REPLY TO PRE-BID QUERIES

BIDDING DOCUMENT NO. : MEC/23TS/01/51/S2/VL/SU/0008
 SUBJECT OF BIDDING DOCUMENT : SUPPLY OF VALVES

TECHNICAL CORRIGENDUM #1

FIGURE - 1

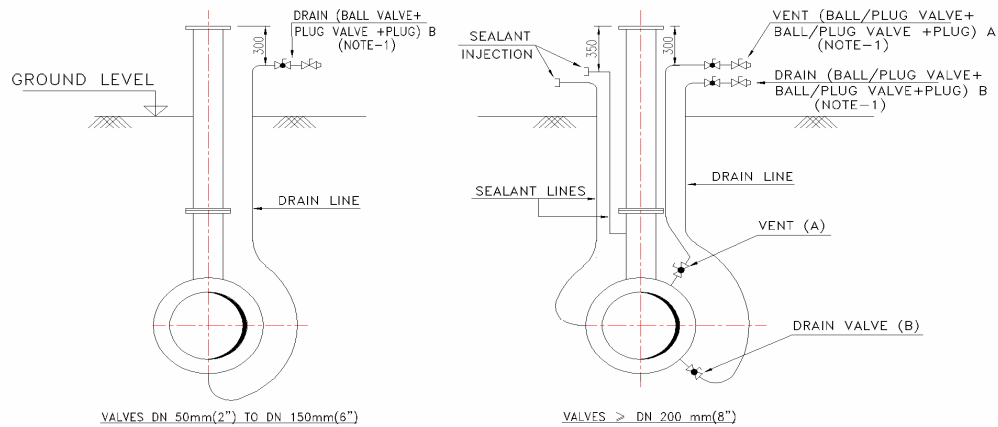
3.	Part-III, Section-II, Technical Specification for Ball valves (TS No.: MEC/TS/05/21/002) cl. no. 4.8	-	Figure-1 for arrangement of valves	Please provide the Figure-1 as mentioned in this clause.	Refer Corrigendum#1

Sn. No.	Volume of Bidding Document	Section	Page No.	Clause No.	Clause Description	Additions / Deletions / Modifications
1.	PART-II	Section-II, Technical Specification for Ball valves (TSNo.: MEC/TS/05/21/002)	-	cl. no. 4.8	Figure-1 for arrangement of valves	Enclosed herewith as Annexure- I.
